500 Fairview Development Objectives

Design Response to Second Early Design Guidance Meeting

On December 1st 2010 the second EDG meeting was conducted. In response to comments made at this meeting specific changes have been made to the design. This package reflects the current design with the following changes:

Typical Single Tenant Plan

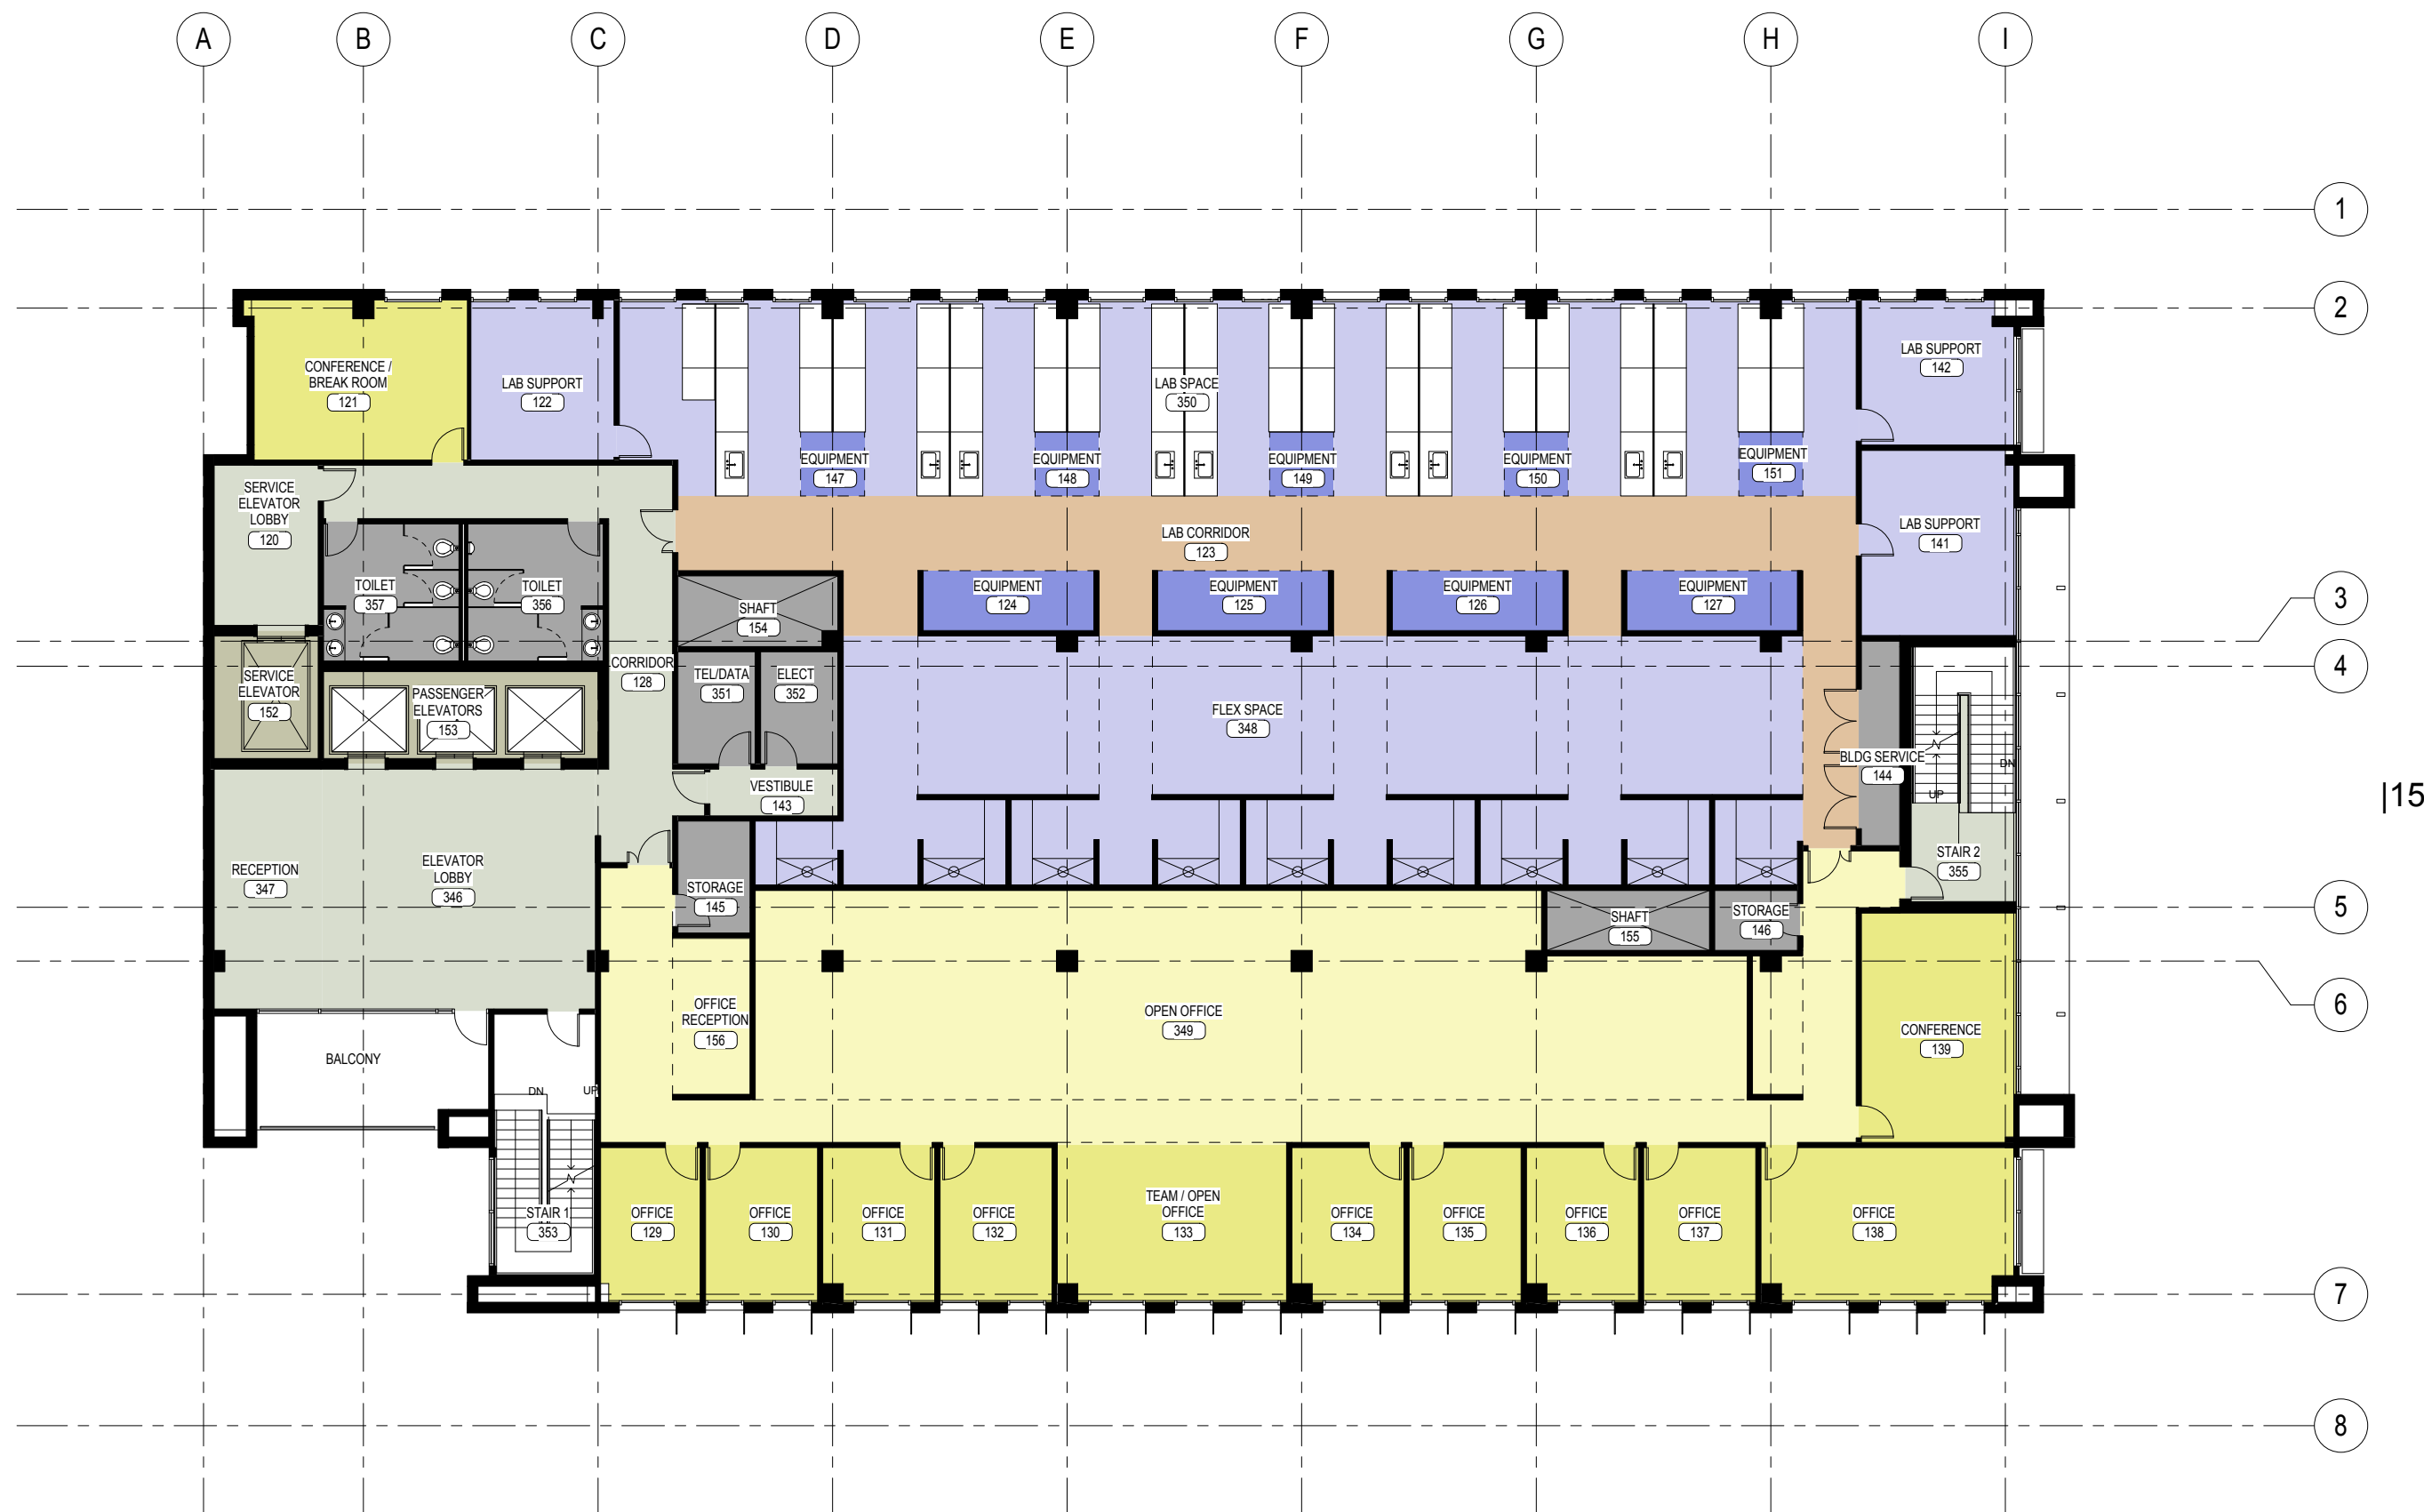
2. Lab layouts, relationship of views to apartments across the alley.

- This package includes two proposed layouts of Laboratory spaces. Due to the speculative nature of this development, these plans are shown for functional use and are not necessarily the layouts that the tenants will design for their spaces.

- The narrow width of the area in the northeast corner of the plan will restrict the types of uses in that area.
- The lab layouts show a single tenant and a multi tenant floor. In both plans, the northeast corner of the plan directly across from the Pete Gross House project is shown used for conferencing functions. In addition, we have redesigned the facade of the building in that location to reduce the amount of vision glass. Adjustable blinds will be provided in those spaces.
